**PCN# PCN20130327000  
Additional Pb Free Lead Finish and expansion of capacity  
(ASE-Shanghai) for Selected SOIC (D) products.  
Change Notification / Sample Request**

**20130327000**  
**Attachment: 1**

<b>PCN Number:</b>	20130327000		<b>PCN Date:</b>	03/28/2013	
<b>Title:</b>	Additional Pb Free Lead Finish and expansion of capacity (ASE-Shanghai) for Selected SOIC (D) products.				
<b>Customer Contact:</b>	PCN_ww_admin_team@list.ti.com		<b>Phone:</b>	+1(214)480-6037	
<b>Dept:</b>	Quality Services				
<b>Proposed 1<sup>st</sup> Ship Date:</b>	06/28/2013		<b>Estimated Sample Availability:</b>	As stated below	
<b>Change Type:</b>					
<input checked="" type="checkbox"/> Assembly Site	<input type="checkbox"/>	Assembly Process	<input checked="" type="checkbox"/>	Assembly Materials	
<input type="checkbox"/> Design	<input type="checkbox"/>	Electrical Specification	<input type="checkbox"/>	Mechanical Specification	
<input type="checkbox"/> Test Site	<input type="checkbox"/>	Packing/Shipping/Labeling	<input type="checkbox"/>	Test Process	
<input type="checkbox"/> Wafer Bump Site	<input type="checkbox"/>	Wafer Bump Material	<input type="checkbox"/>	Wafer Bump Process

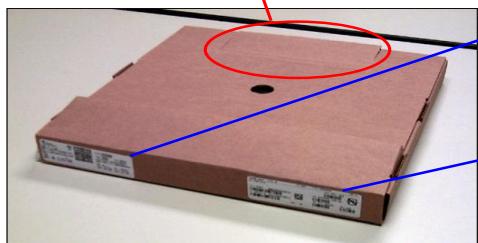
**No change** to TI Manufacturing Label and Customer Label (if applicable). Each reel, pizza boxes and standard packing boxes includes the correct ECAT symbols based on the appropriate lead frame finish.

G4 = NiPdAu/Ag  
G3 = Matte Sn

**Each** "pizza box" and reel will carry the appropriate label clearly identifying lead finish as described above.
